ZRD1: Zoning Resolution Determination Form

House No(s) 217 Street Name West 57th Street
Borough Manhattan Block 1029 Lot 19 BIN 1080870 CB No. 105

This ZRD1 seeks reconsideration of the denial dated March 17, 2014 (the "Determination") of a zoning determination request filed under Control No. 32477. The request was made in respect of an application to construct a new building ("Building") at 217 West 57 Street in Manhattan ("Property") which is now being reviewed by the Department of Buildings (the "Department") under NB# 121328205. It asked that the Department confirm that heat pumps used to provide heat and air conditioning qualify as "mechanical equipment" and that the demised spaces in which they are installed are excluded from the calculation of floor area in accordance with Section 12-10 of the Zoning Resolution.

1
ZSK-23.2

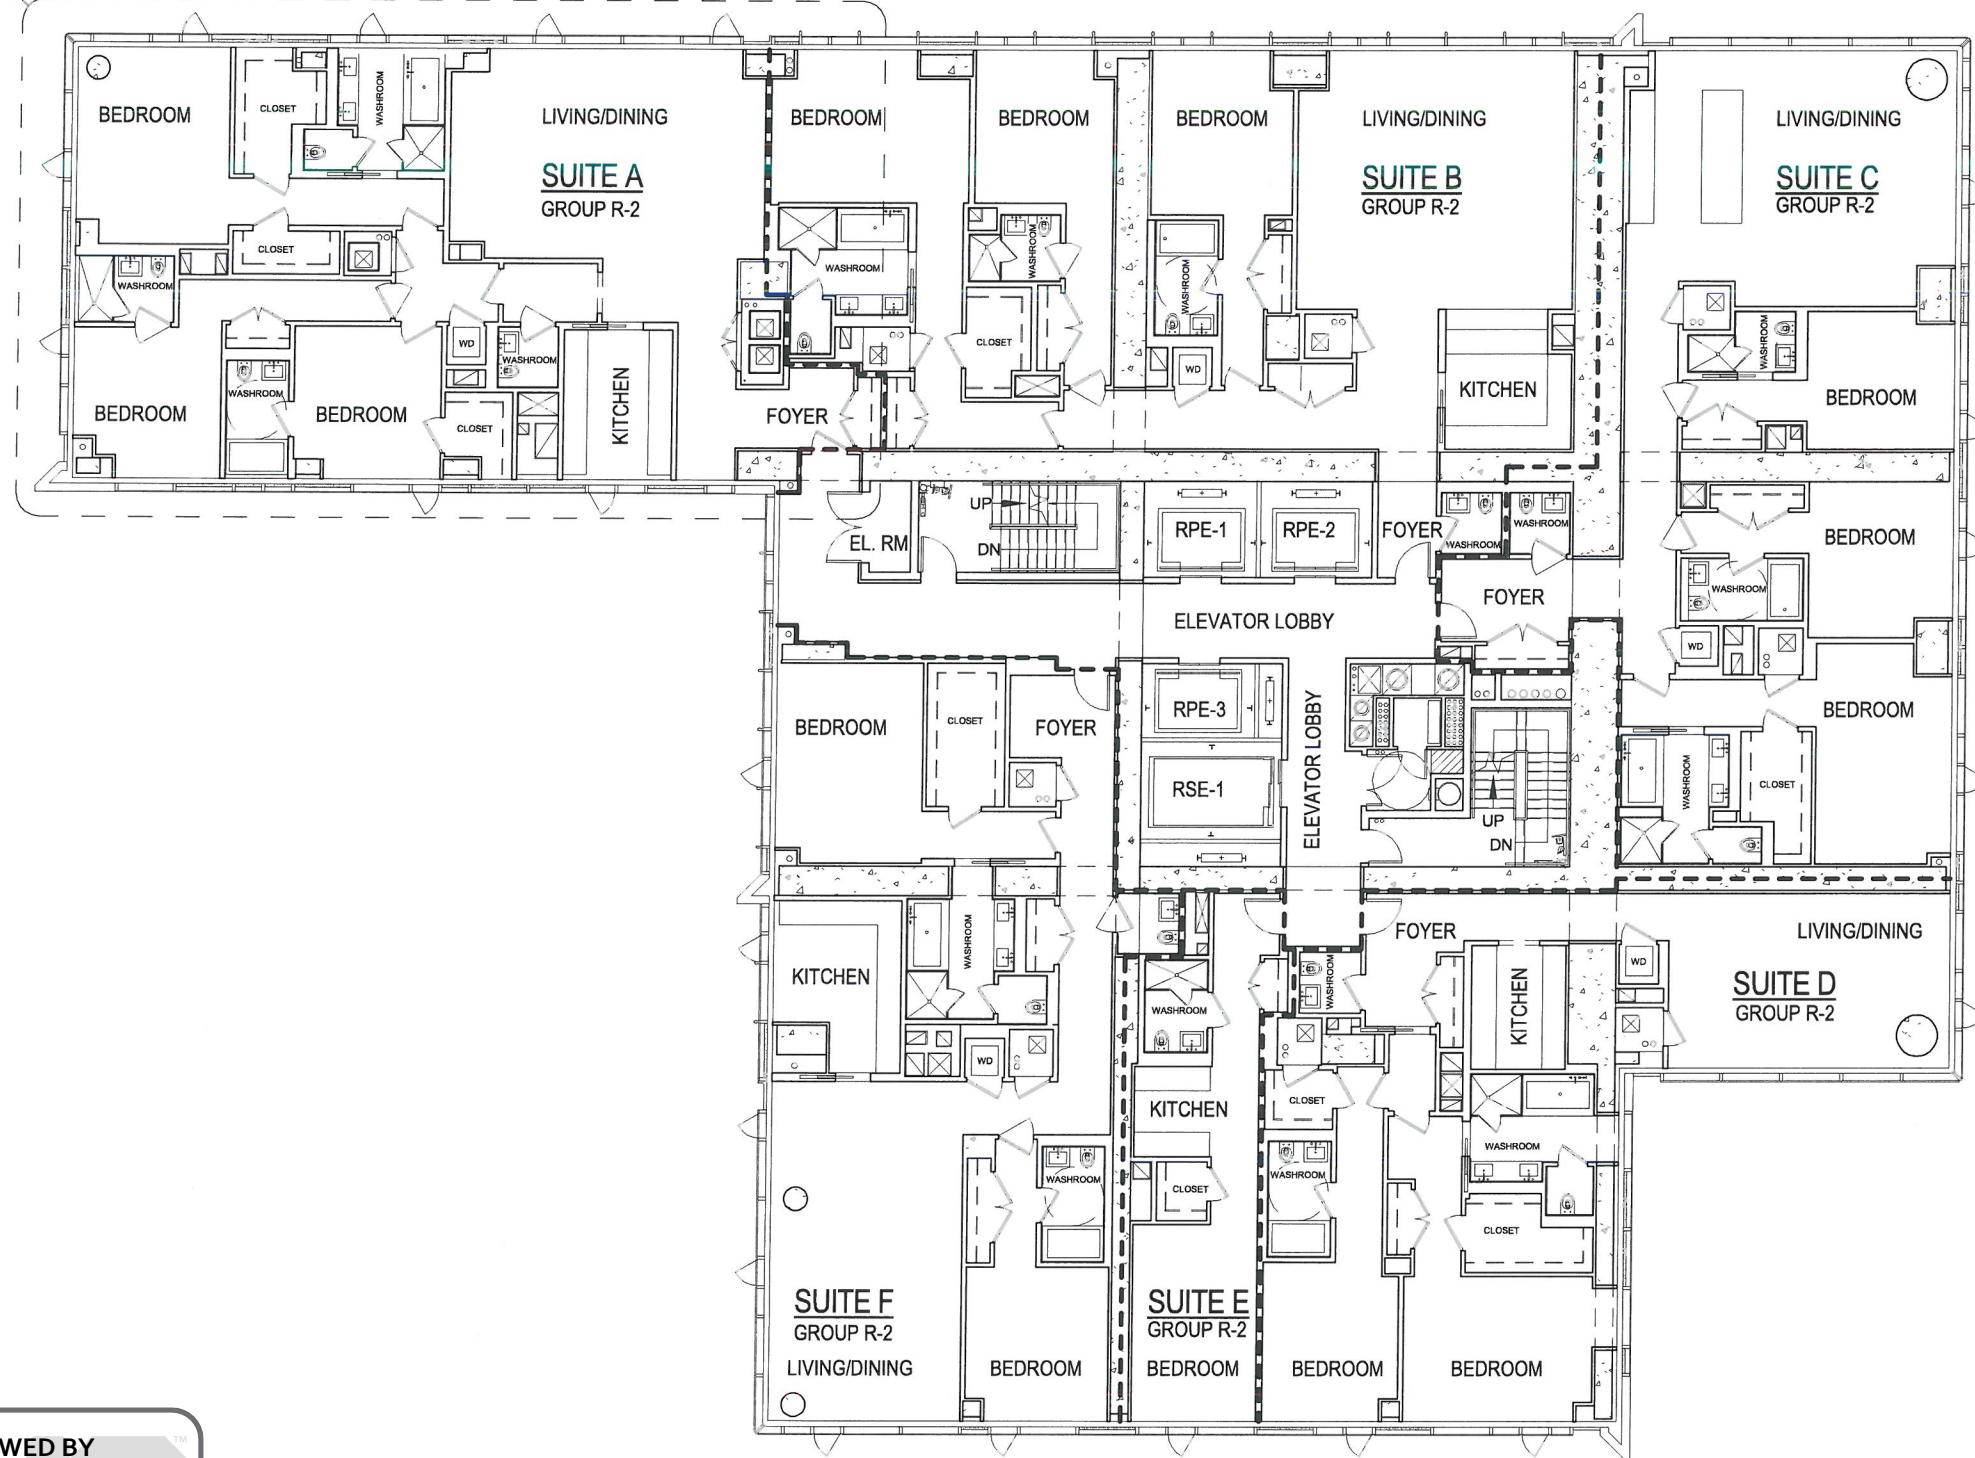
Each heat pump enclosure is full height floor to ceiling minimally sized to contain the building water risers to serve the vertical heat pump units along with both supply and return ductwork and controls. The vertical heat pump supply ductwork runs to the top of the enclosure and then is distributed through the zone of the space to provide the needed cooling and heating to condition each residential floor depending on the temperature requirements through air outlets in the ceiling and walls. The return ductwork is located at the top of the heat pump enclosure and extends into the ceiling space to bring return air back to the unit. This is completely different from individual stand-alone radiators, convectors or air conditioning units such as through-the-wall units, called "PTAC" units which are situated under the windows of the dwelling unit and are not floor to ceiling.

TYPICAL RESIDENTIAL FLOOR PLAN - VERTICAL HEAT PUMP ENCLOSURE
DATE: MARCH 28, 2014
DWG #: ZSK-23.1

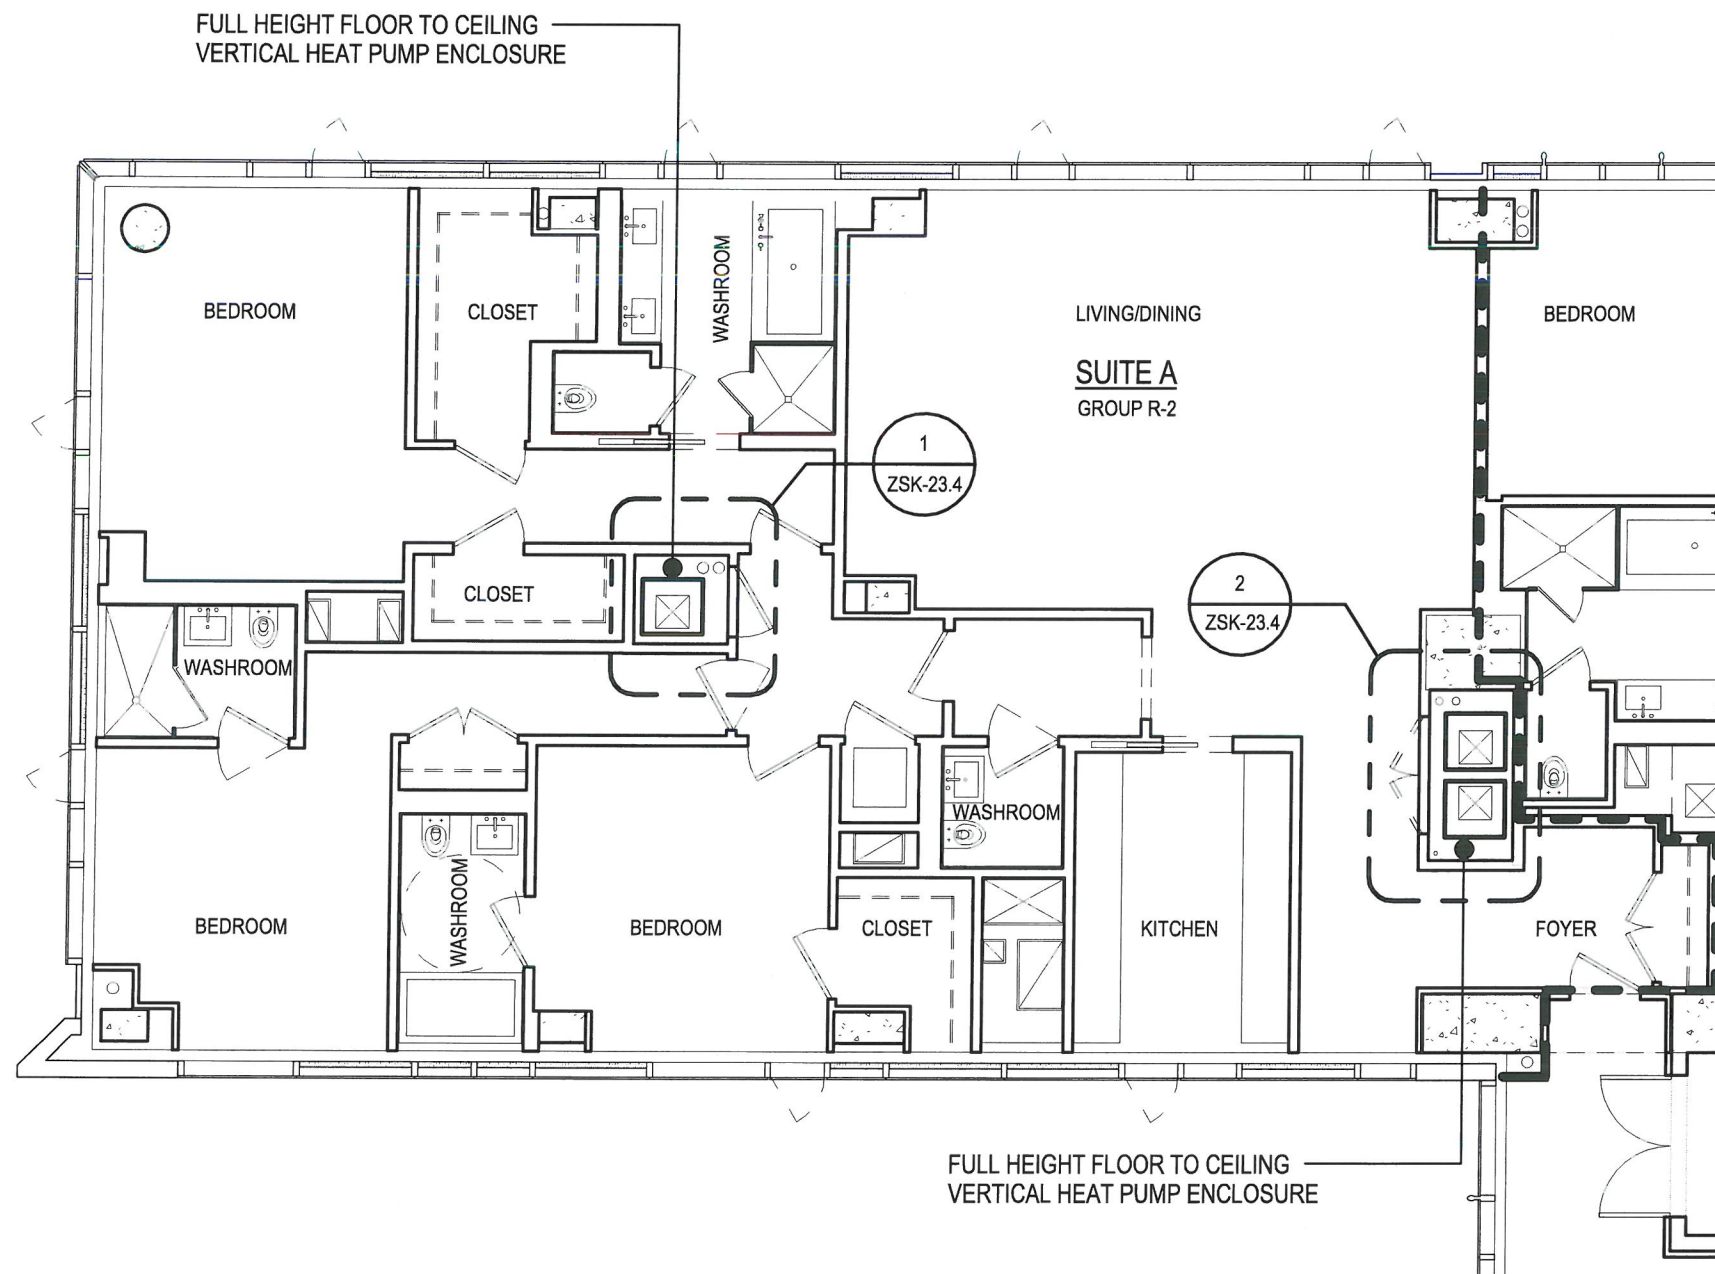
Each heat pump will be demised within a floor-to-ceiling enclosure that also will contain both the hot and cold water risers necessary to serve all of the heat pumps in that line and the supply and return air ducts for the apartment unit. This volume of space is unfinished and uninhabitable, is segregated from living spaces within the Building, and, as indicated on drawings filed with this request, is no larger than is absolutely necessarily to house the equipment and provide space for its maintenance. Each enclosure will be accessible only by maintenance access panel. The nature and configuration of the proposed heat pumps is completely different from the individual radiators, convectors and air conditioning units (including portable, window box, in-wall or packaged terminal air conditioning units) and the spaces that house them – spaces that the Department has interpreted as counting toward floor area – in that, unlike the heat pumps, none of these units both condition and centrally distribute air and none are located in uninhabitable floor-to-ceiling enclosures.

- The enclosures within which the heat pumps are installed are, unlike radiators, convectors and air conditioning units, fully demised from the habitable spaces in the building and sized no larger than is necessary to accommodate the heat pumps themselves, the risers that serve them, the ductwork connected to them, and an adjacent area for service.

Because the proposed heat pumps located within dwelling units (i) are minimally sized, (ii) are within a fire rated enclosure, and (iii) occupy floor space from floor to ceiling resulting in no usable space within such area, such heat pumps may be excluded from the calculation of floor area as "mechanical equipment" as per ZR 12-10 "floor area", paragraph (8), and the request is approved.
